Subject: **Shinglemill – Chapter 40B Comprehensive Permit**

This is to advise that we have reviewed the following documents related to the proposed Shinglemill Chapter 40B development off Pond Street:

The documents have been revised to address comments contained in our May 30, 2023 letter to the Board as well as comments from others as listed above. Below are the comments from our May 30 letter in plain text, followed by the current status of each in **bold text**.

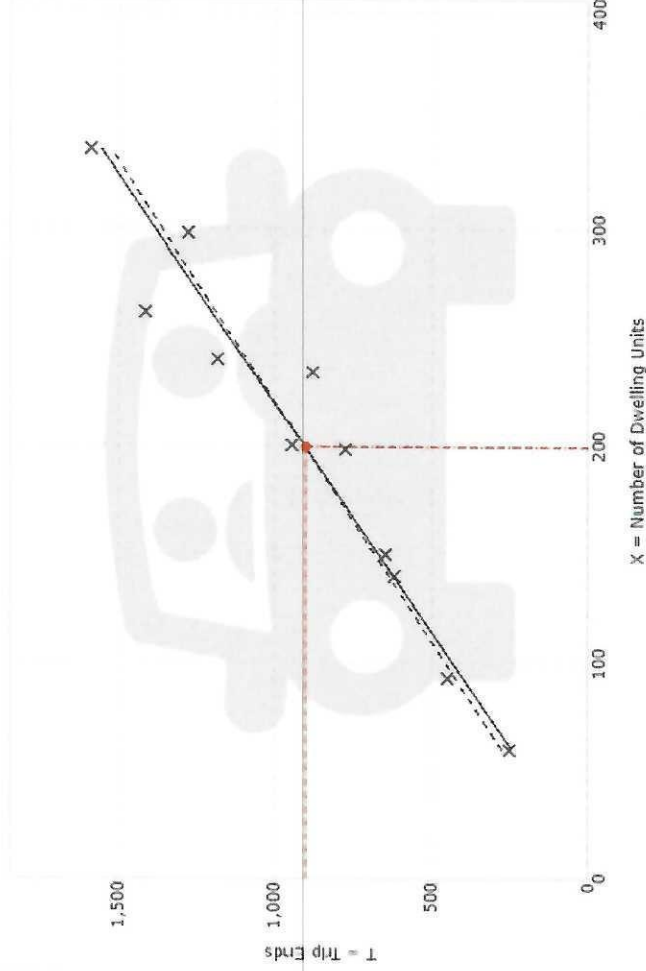
4. The project as proposed will require the Applicant to file an Environmental Notification Form (ENF) with the Massachusetts Environmental Policy Act (MEPA) since it will trigger the MEPA Review Threshold 301 CMR 11.03(6)(b)(14). This requires submission of an ENF for a project that will generate 1,000 or more new average daily trips on roadways providing access to a single location and construction of 150 or more new parking spaces at a single location. The project proposes 299 parking spaces and 199 residential units, which will generate 1,082 average daily trips to this location. **In the response, Coneco explains that an ENF is not required and cites the McMahon memorandum which indicates that the project will generate 904 average daily trips. We confirmed this number with Gillon Associates (see attached trip generation results) so at this point we agree that an ENF is not required.**
